INSTRUCTIONS FOR UPDATING YOUR ER

BRAIDWOOD NUCLEAR GENERATING STATION - UNITS 1 & 2

ENVIRONMENTAL REPORT - OPERATING LICENSE STAGE

FIGURE 2.1-3

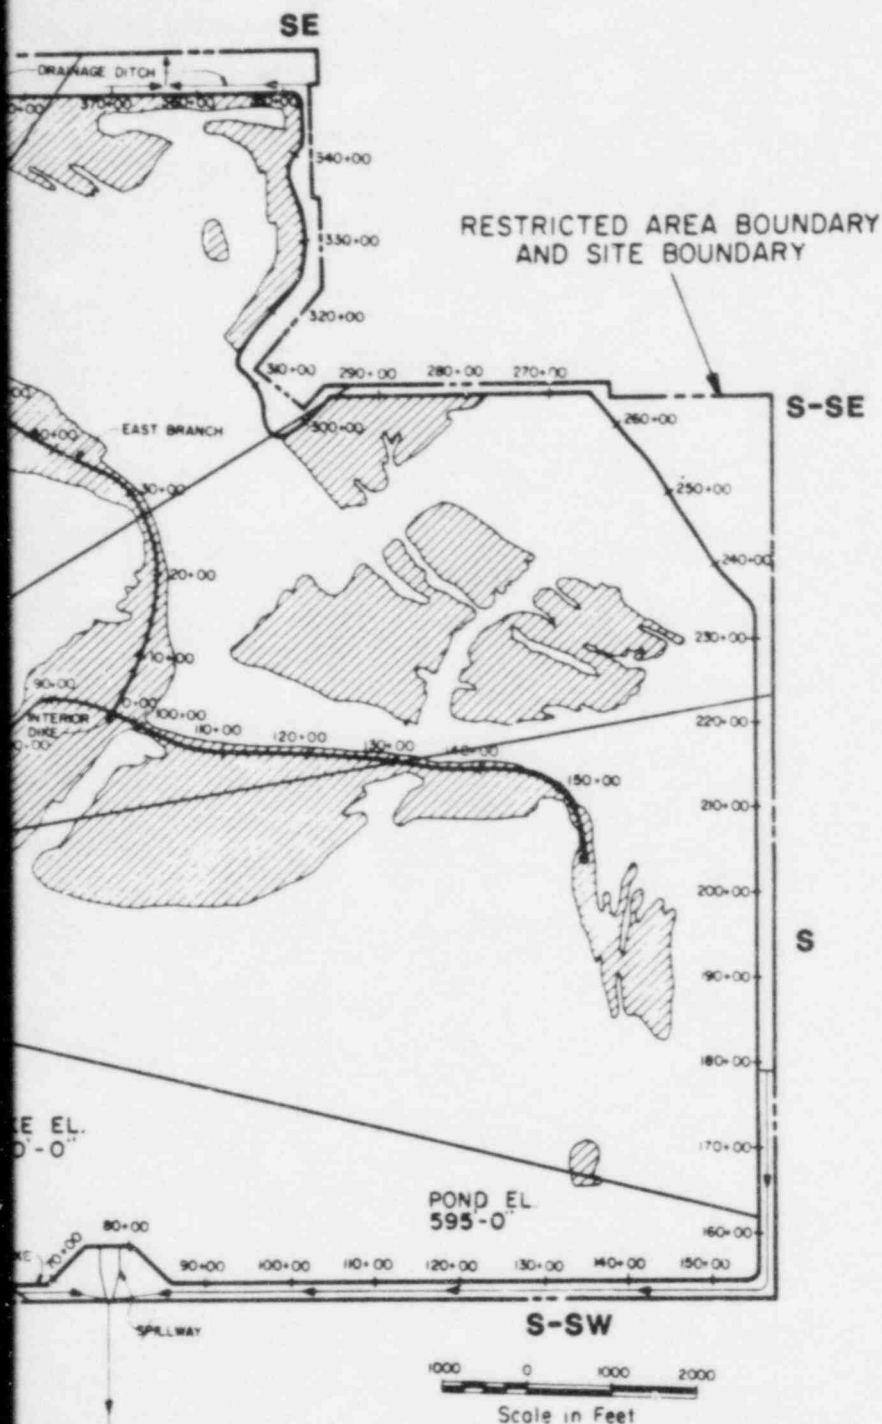
QUESTION E291.3

Describe the area, volume and purpose of the "fresh water holding pond" shown on Figure 2.1-3.

BRAIDWOOD NUCLEAR GENERATING STATION UNITS 1 & 2 ENVIRONMENTAL REPORT - OPERATING LICENSE STAGE
FIGURE 2.5-2 SITE AGRICULTURAL SOILS MAP

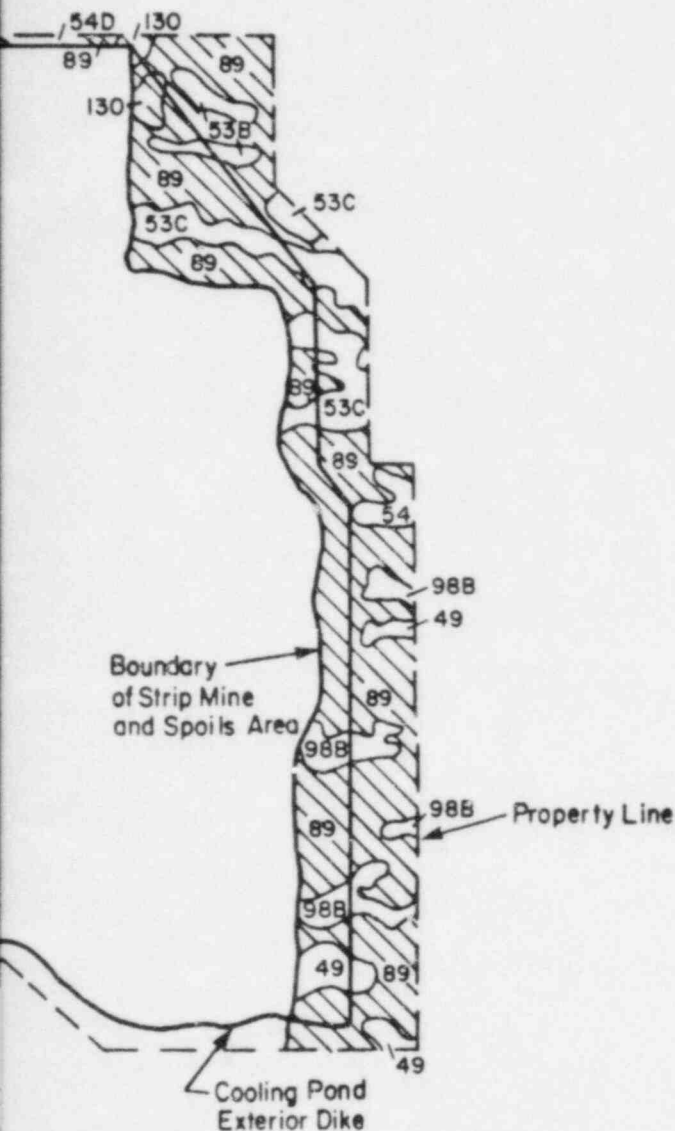
QUESTION E290.3

Figure 2.5-2 of the ER has been revised and it now illustrates the extent of prime agricultural land on the Braidwood Station site prior to construction. There is no unique or locally important agricultural land on the site.

FIGURE 3.3-1

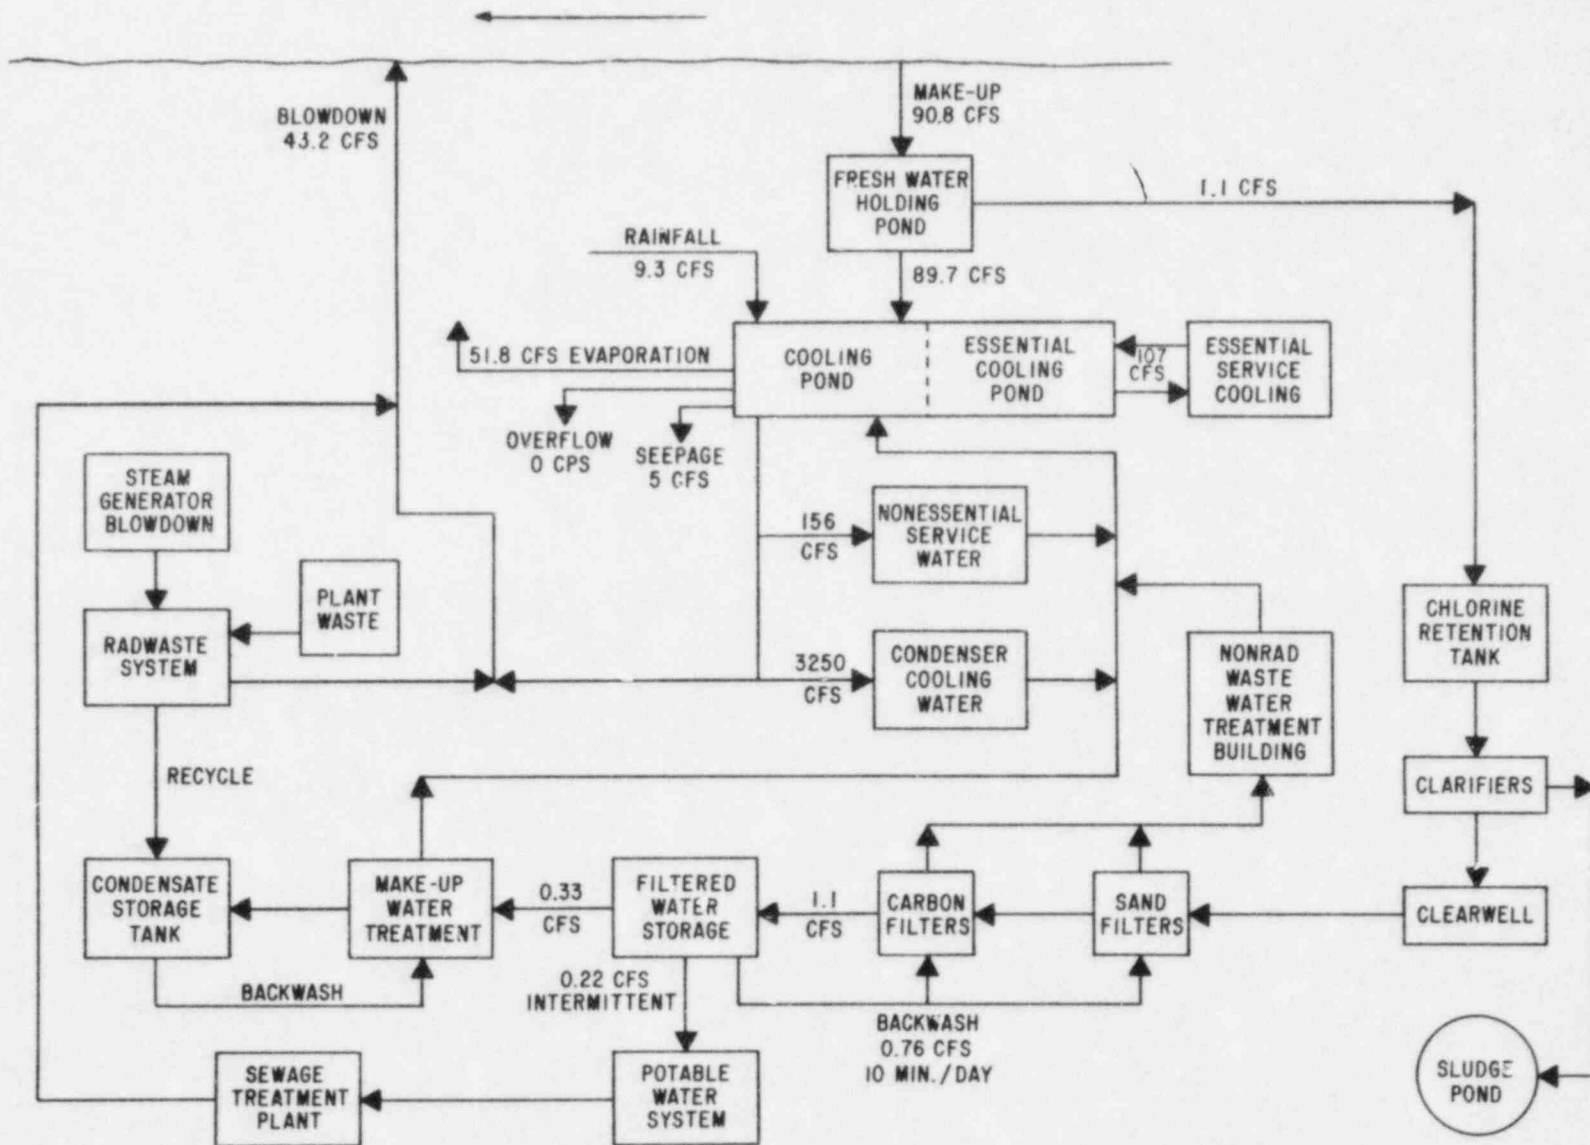
QUESTION E291.16

The differences in average flows reported are due to different averaging periods being used for each flow. The estimated average annual flow rate of 3952 cfs for the Kankakee River at the screenhouse was obtained from the flow records published by U.S. Geological Survey at the Wilmington Gaging Station for the period 1933-1976. This average flow of 3952 cfs will be used in this ER. Figure 3.3-1 and ER Table 11.0-1 have been amended to include this flow rate.
